STAFF REPORT AMENDED 5-26-83  
CITY PLANNING COMMISSION

- APPLICATION:
1. Environmental Determination
  2. Rezone proposed corner lots from Single Family (R-1) to Townhouse (R-1A)
  3. Tentative Map

LOCATION: West of Pocket Road at Little River Drive

APPLC. NO. P83-107

## TENTATIVE MAP

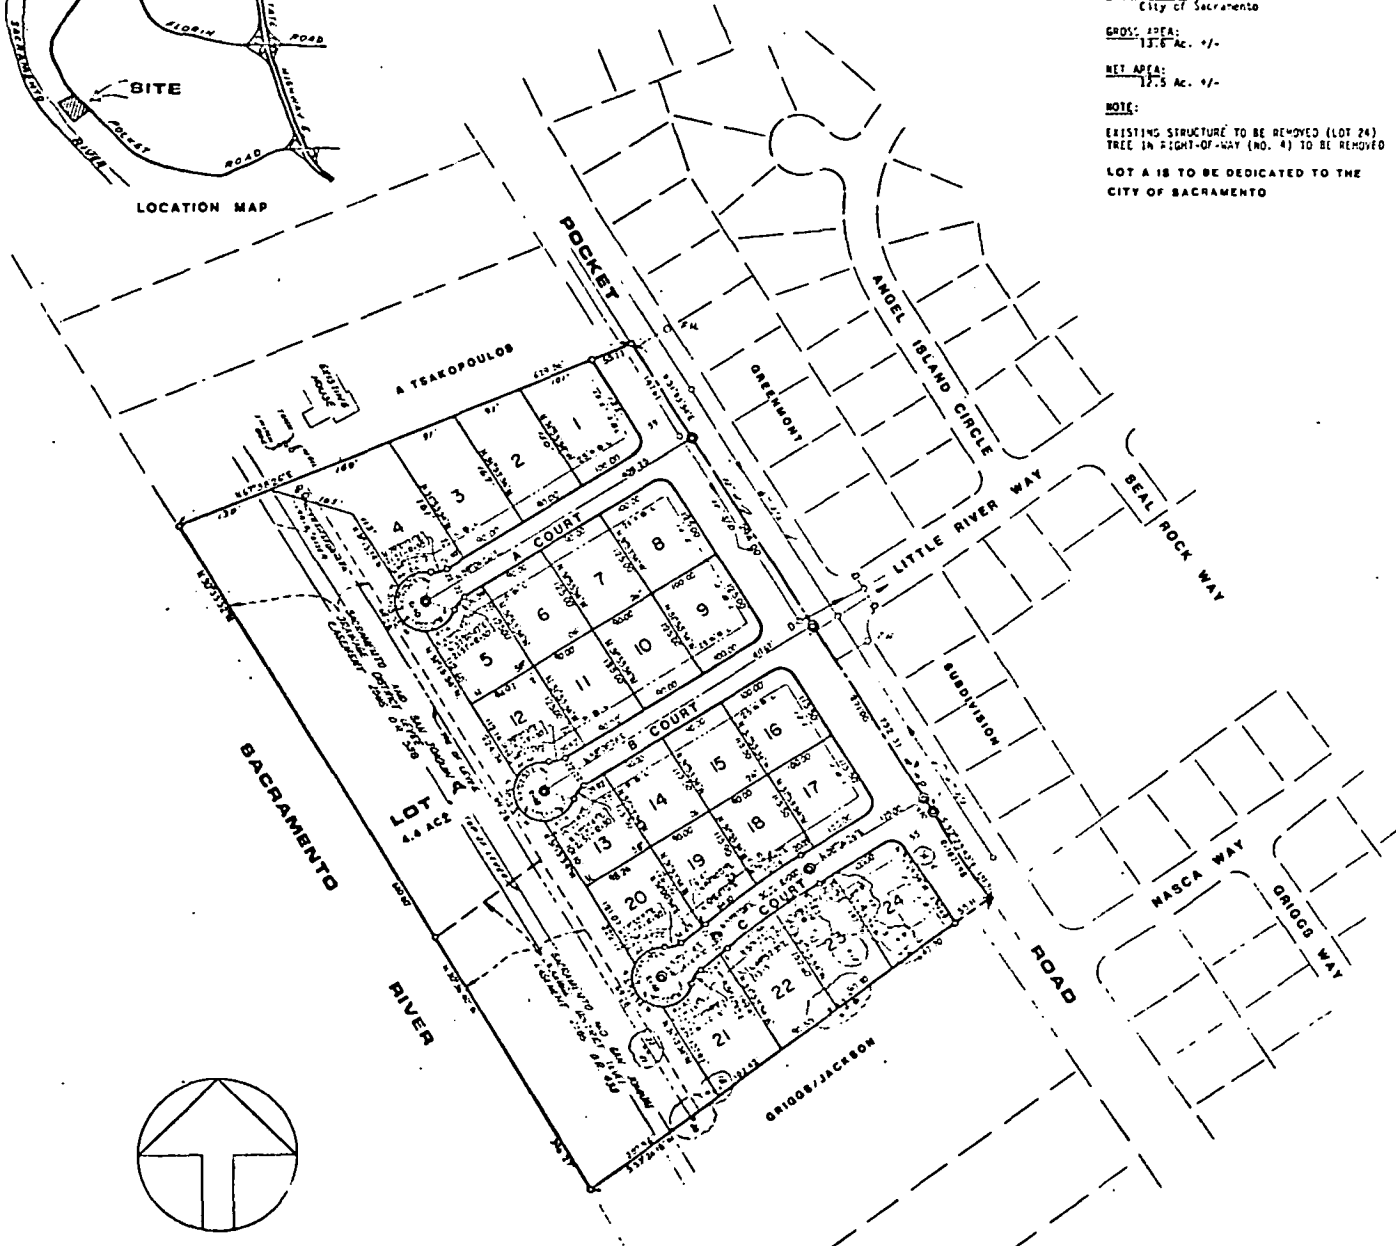
1. The applicant proposes to retain ownership of lot 'A' and merge it with the parcel to the north, which is also under his ownership. This would make the project inconsistent with design standards of the South Pocket Specific Plan regarding acquisition of land for the Sacramento River Parkway. Such land has been acquired by fee title in the past. Staff therefore requests that approval of the map be based on Exhibit 'B'. The triangular remnant is to be merged with Lot 'B'. Lot 'A' is to be dedicated in fee to the City.

2. A well, tank, switch box, irrigation riser and transformer which provides utilities to the existing house are located in the Parkway Corridor strip. In order for the applicant to retain ownership of this equipment, staff has drawn Lot 'B' to extend into the Parkway Corridor. In this case, it would be infeasible to require dedication in fee.

- i. The map shall be redrawn to include the adjacent parcel to the north and shall reflect staff's Exhibit 'B';
- j. Existing on-site trees shall be retained unless prior approval has been received by the Planning Director after consultation with the City Arborist;

- m. The map shall be redrawn to include the adjacent parcel to the north. Lot 'A' shall include the Parkway Corridor which is measured from the low mark of the Sacramento River to 10 feet east of the landward toe of the levee. Lot 'A' shall be dedicated in fee to the City. The remnant parcel shall be merged with the parcel to the north;

# REZONING EXHIBIT

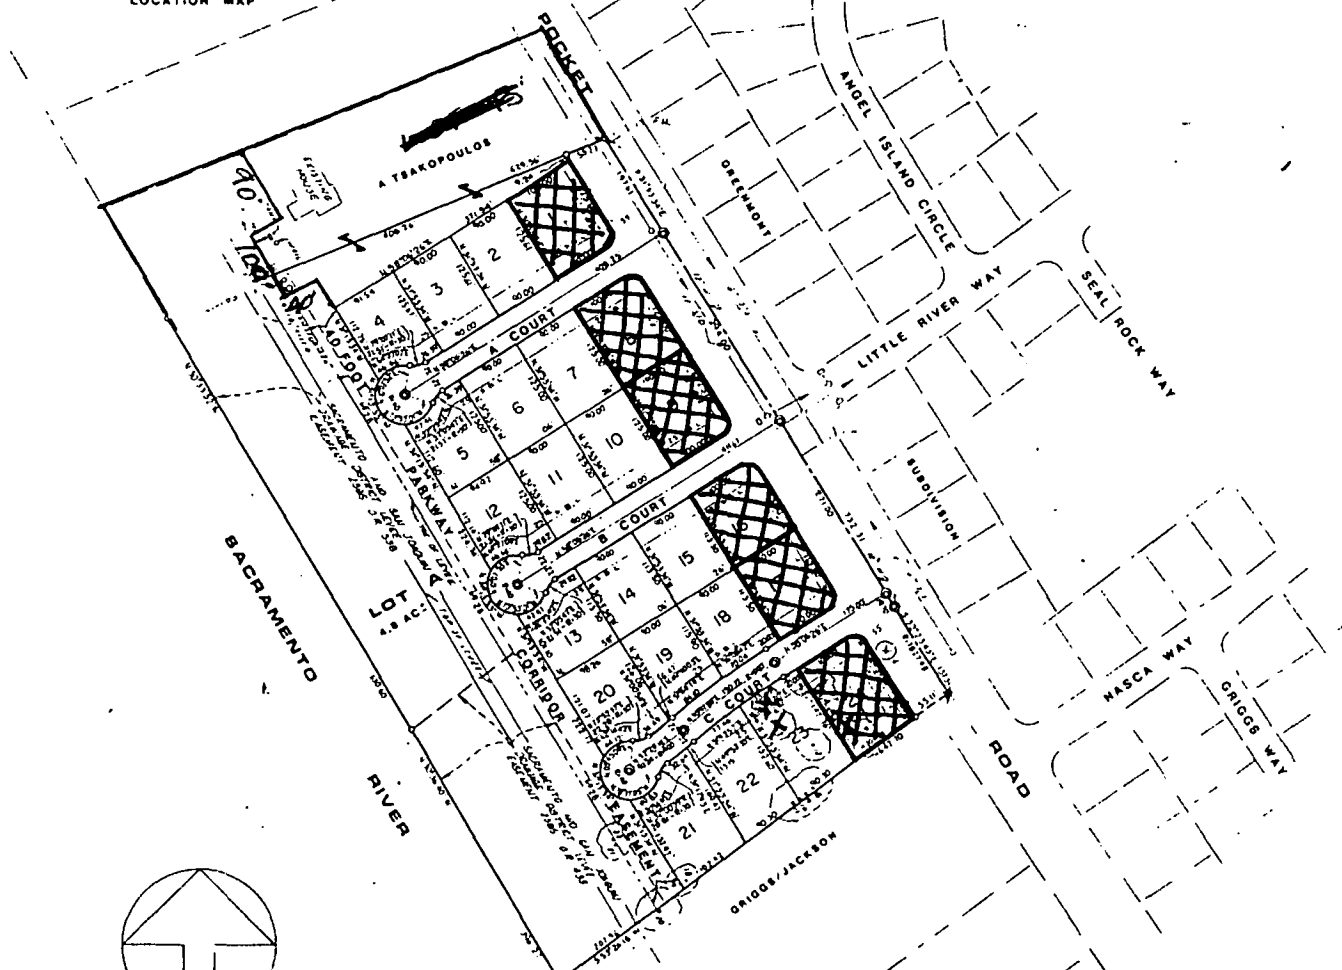
5. The applicant is proposing to rezone the corner lots to R-1A for future halfplex development. Staff has no objection to the rezoning since it represents no increase in density over the R-1 zone. Specific plans for the halfplex will be reviewed when the special permit for halfplex development is submitted.
